Appl. No. 10/707,152

Amd. Dated October 14, 2005

Reply to Office Action Dated June 8, 2005

Amendments to the Drawings:

FIG. P1

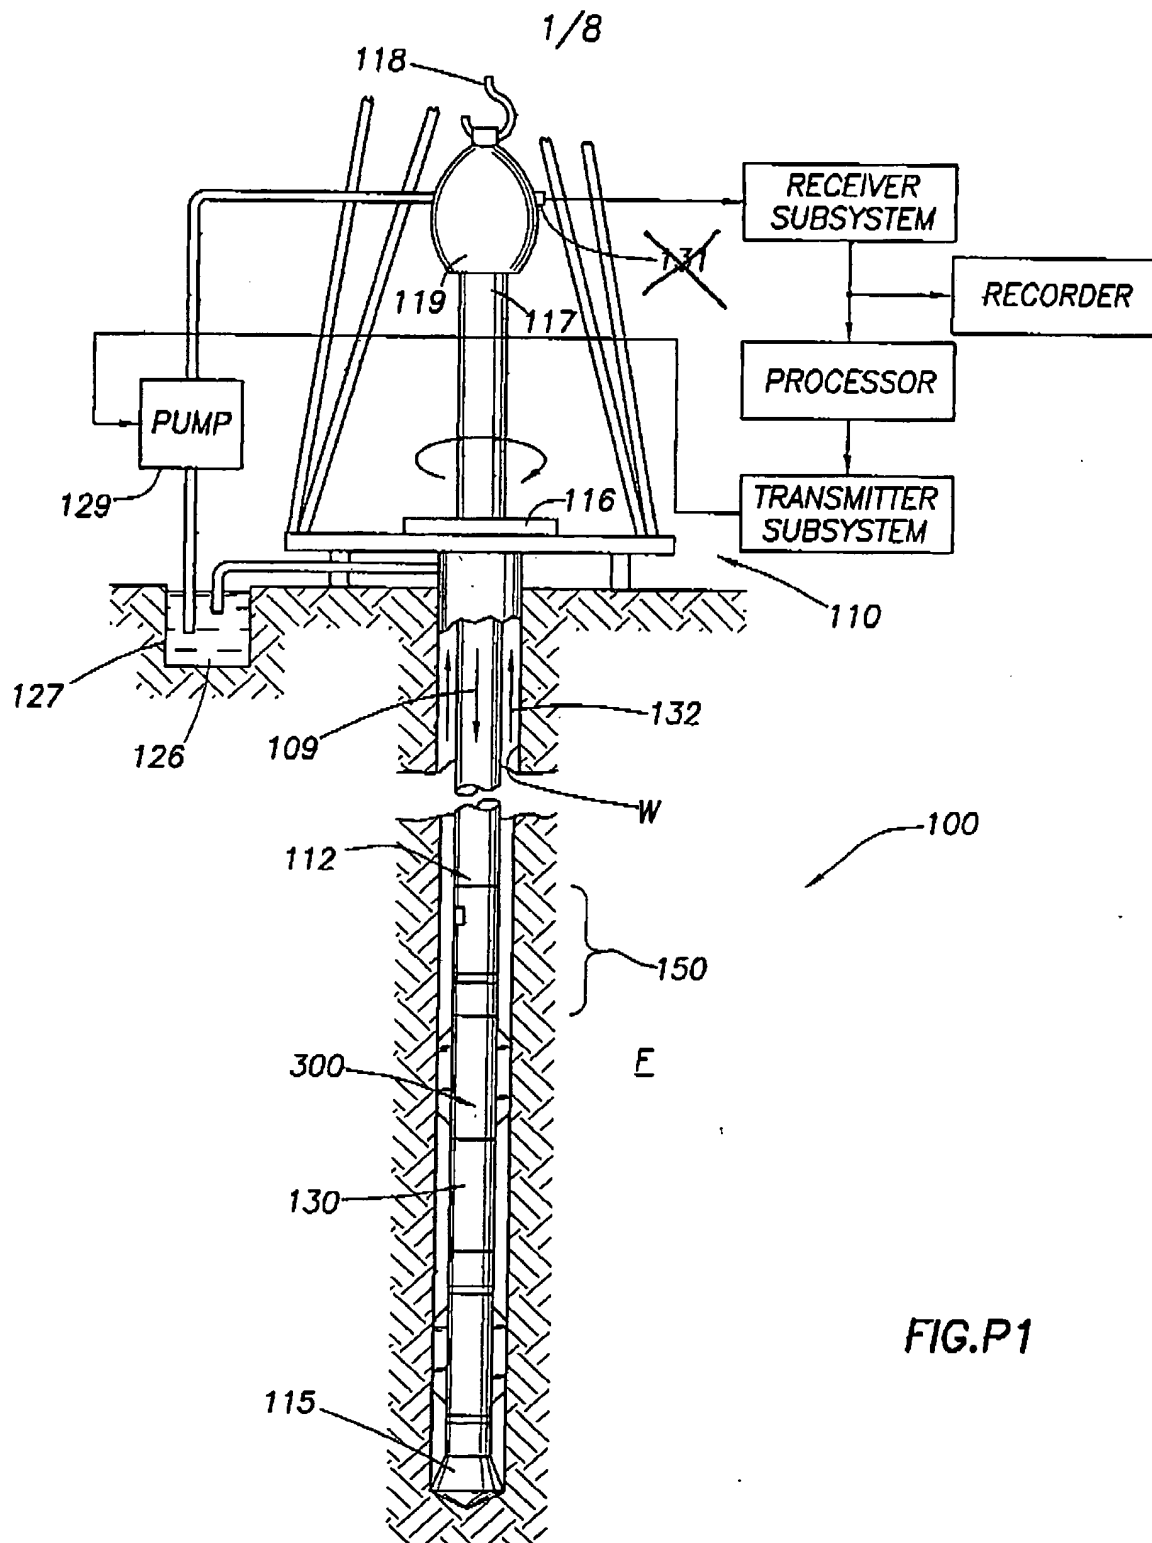
The attached sheet of drawings includes changes to Figs. P1 and 16A. These sheets, which includes Figs. P1, 16A, 16B, 17A and 17B, replaces the original sheets including Fig. P1, 16A, 16B, 17A and 17B. In Fig. P1, reference number 131 has been removed. In Fig. 16A, duplicate reference number 44 has been changed to reference number 41.

Applicant has detected certain errors in the specification and drawings and has submitted amendments herein to correct these errors. In the drawings, Applicant has removed reference number 131 of Fig. P1, and replaced duplicate reference number 44 with 41 in Fig. 16A to conform to Fig. 16B.
